# Staff Report

Re: PLNPCM2020-00358 - Detached Accessory Dwelling Unit  
PLNPCM2020- 00454 - Special Exception for Grading and Retaining Walls

## Conditional Use and Special Exception

**PROPERTY ADDRESS:** 1362 S 1300E  
**PARCEL ID:** 16-17-226-029-0000  
**MASTER PLAN:** Central Community – Low Density Residential  
**ZONING DISTRICT:** R-1/5,000 Single Family Residential

Figure 1: Site plan – Retaining walls requiring a special exception are outlined in red and the buildable area is outlined in orange.

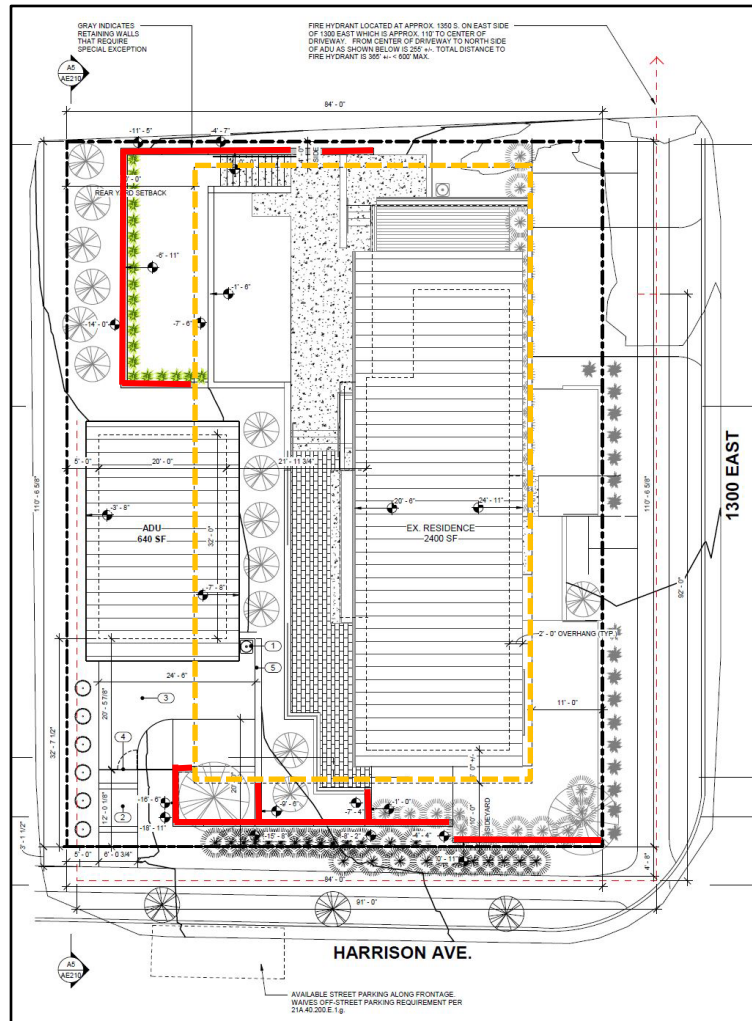
The applicant is also applying for a Special Exception to allow grade changes and retaining walls exceeding 4 feet (4’) outside of the buildable area. Due to the approximate 26-46 percent (26% - 46%) slope of the property, the construction of the proposed ADU will require grading within the rear and side yards that exceeds the 4-foot (4’) limitations. The slope of the property increases from south to north. The applicant provided a written statement on their grading plans stating that the retaining walls are required in the locations indicated to create a large enough building pad for the ADU. The grading and retaining walls on the north end of the property are being proposed to create a useable outdoor area for the occupants. Currently, the rear yard is at such a slope that it cannot be used by property owners. Retaining wall RW10 is integrated into the ADU and acts as its eastern wall, allowing the structure to be set into the slope of the lot. The detailed grading site plan and elevations are located in [Attachment C](#). Figure 1 highlights the retaining walls requiring special exception approval in red. The buildable area is outlined in orange.

Figure 2: Site elevation – Retaining walls (#3-6) along Harrison Avenue exceed 4 feet and require special exception approval.

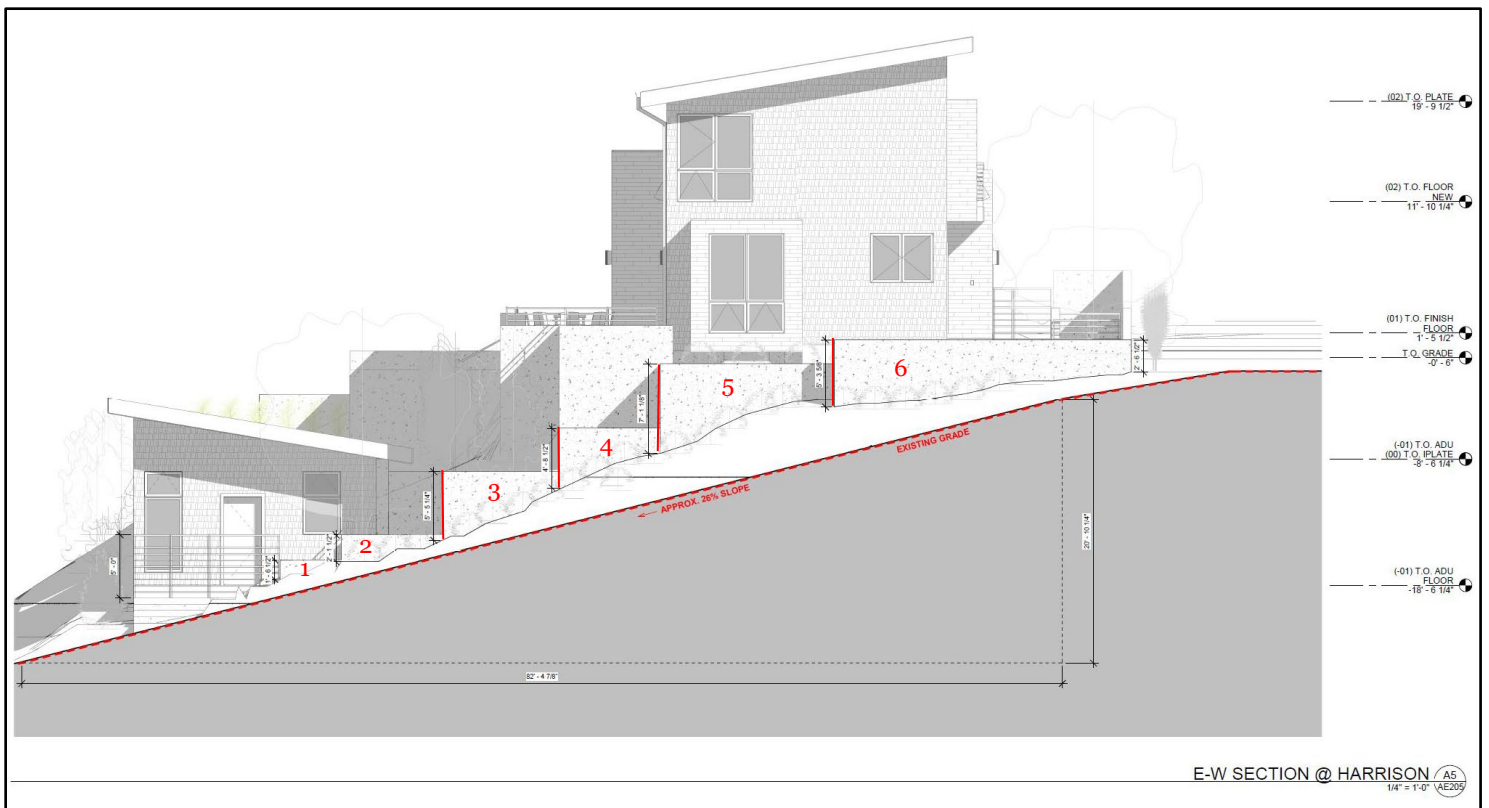
The southern (side yard) property line running east-west along Harrison Avenue has an existing slope of approximately 26 percent (26%). The applicant is proposing six (6) terraced retaining walls within the side yard setback. Four (4) of the six (6) walls require special exception approval because they exceed four feet (4') in height. The heights range from approximately 4 feet 8 inches (4'8") to just above 7 feet (7'). The original plans proposed two retaining walls that were nearly 8 and 9 feet tall. Staff was concerned that this would be imposing along the street front and asked the applicant to create more terraces and reduce the exposed height of each individual wall to under 6 feet (6'). The applicant was able to add more terraces, but the 7-foot (7') wall (#5) could not be reduced any further because the top of the wall reaches the existing grade of the upper area of the property. Figure 2 shows the existing slope of the property and the proposed retaining walls along Harrison Avenue. The specific height of each wall from west to east are as follows:

- Wall #1 – 1' 6 1/2"
- Wall #2 – 2' 1 1/2"
- Wall #3 – 5' 5 1/4"
- Wall #4 – 4' 8 1/2"
- Wall #5 – 7' 1 1/8"
- Wall #6 – 5' 3 5/8"

Figure 3: Rendering with the retaining walls requiring special exception approval in red. The overall grade change of 15' 3 1/4" also requires approval.

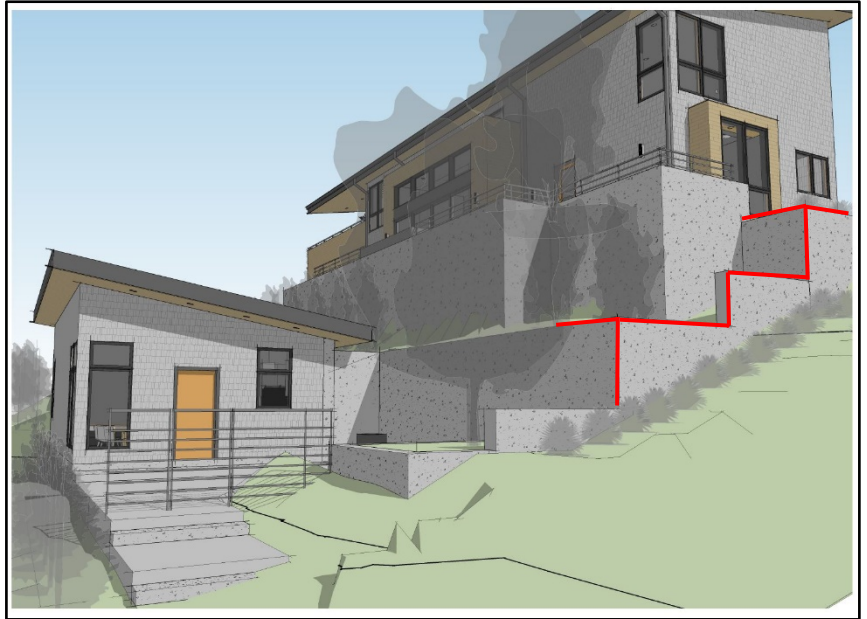
The existing slope where the ADU entrance is proposed to be located is 38 percent (38%). To create a buildable area for the ADU, the existing grade will be cut 15' 3 1/4" and then retained by three walls running north-south. The 9' 11 1/2" exposed retaining wall perpendicular to Harrison Avenue is taller than the walls along the street because the property will slope downward (to the north) approximately two feet. The east side of the ADU will be built into the 9' 11 1/2" retaining wall. The majority of the retaining wall falls within the buildable area, but the southern portion (closest to Harrison Avenue) is within the side yard setback and will require special exception approval. The 9 1/2' retaining wall falls within the buildable area and does not require special exception approval. Figures 3 and 4 shows the proposed changes and where the special exceptions have been requested in red.

Figure 5: Rendering with the retaining walls requiring special exception approval in red. The rear of the ADU will be built into the southern 8' 8 1/2" side of the wall.

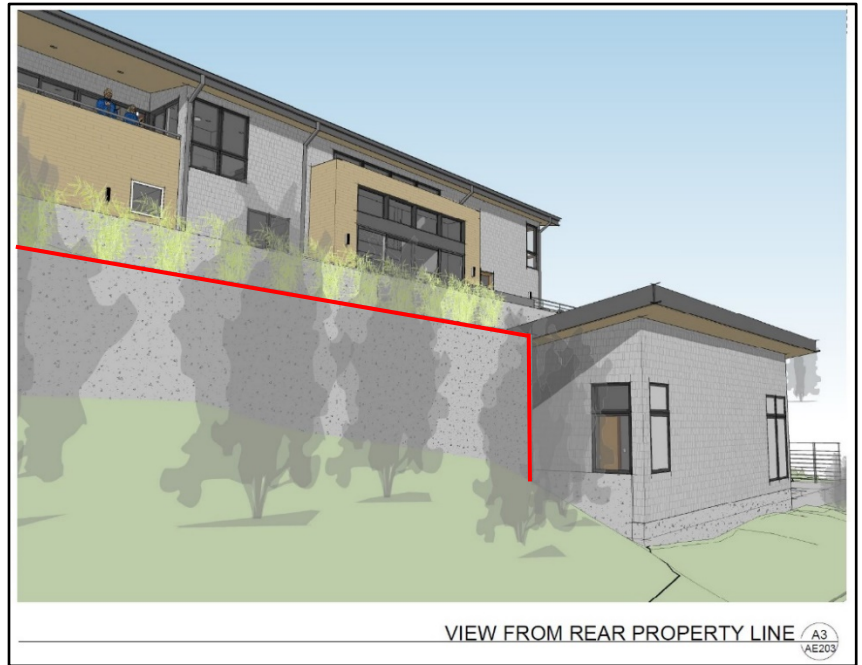
The existing grade along the rear property line (west) will not be altered. The retaining wall running perpendicular (north-south) from the north side property line requires special exception approval because it exceeds 4 feet (4') in height and is within the rear yard setback. The exposed wall will be 5' 2 3/4" at the northern most section and will gradually increase in height to 8' 8 1/2" along the southern most portion of the wall where the existing grade is approximately 46 percent (46%). The north side of the ADU will be into the 8' 8 1/2" retaining wall. Figures 5 and 6 are renderings of the proposal with the retaining walls requiring special exception approval in red. The site section drawing as noted in Figure 7, shows a north to south property section of the existing grade from the rear property line and the proposed retaining wall. Figure 8 is an east-west site section showing the same section of wall. The 5' 4 3/4" and 8' 6" retaining walls are within the buildable area and do not require special exception approval. The applicant is planning to add trees along the retaining wall to help secure the grading and to provide a buffer between the rear yard and the adjacent property to the west. Figure 6 shows the same retaining wall with the proposed landscaping from the middle of the property.

Figure 9: Rendering with the northern side yard retaining walls requiring special exception approval in red.

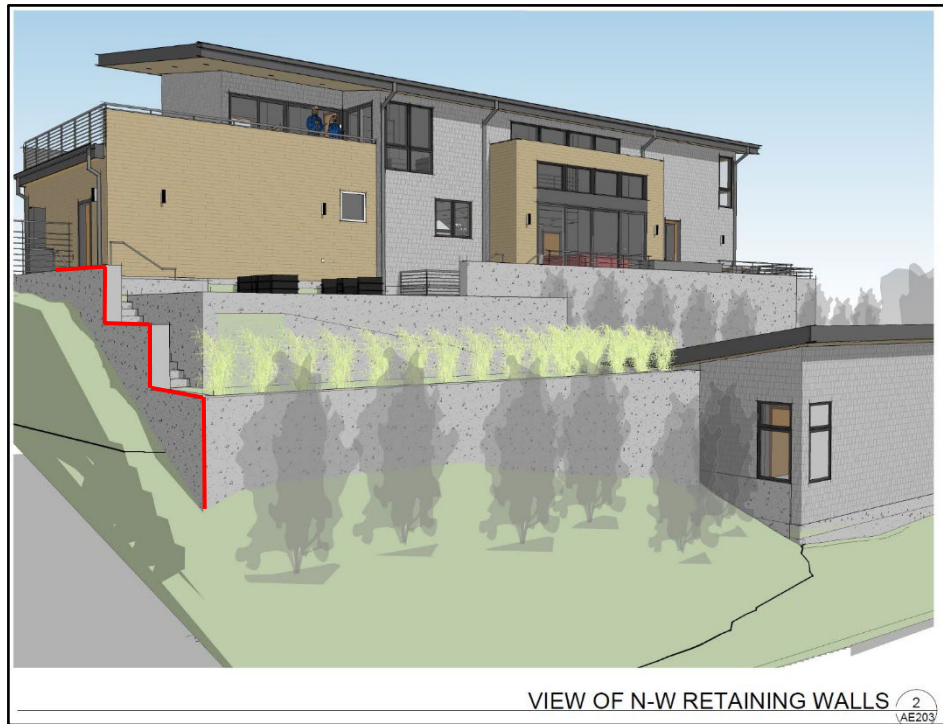
The terraced retaining walls running along the northern property line is within the required side yard setback area. The applicant is proposing this section of terraces walls to create a useable backyard area for the property owners. The three proposed walls fall within the 5-foot (5') range and connect to the retaining wall within the rear yard setback that was described above. The existing grade along the property line will not be altered.
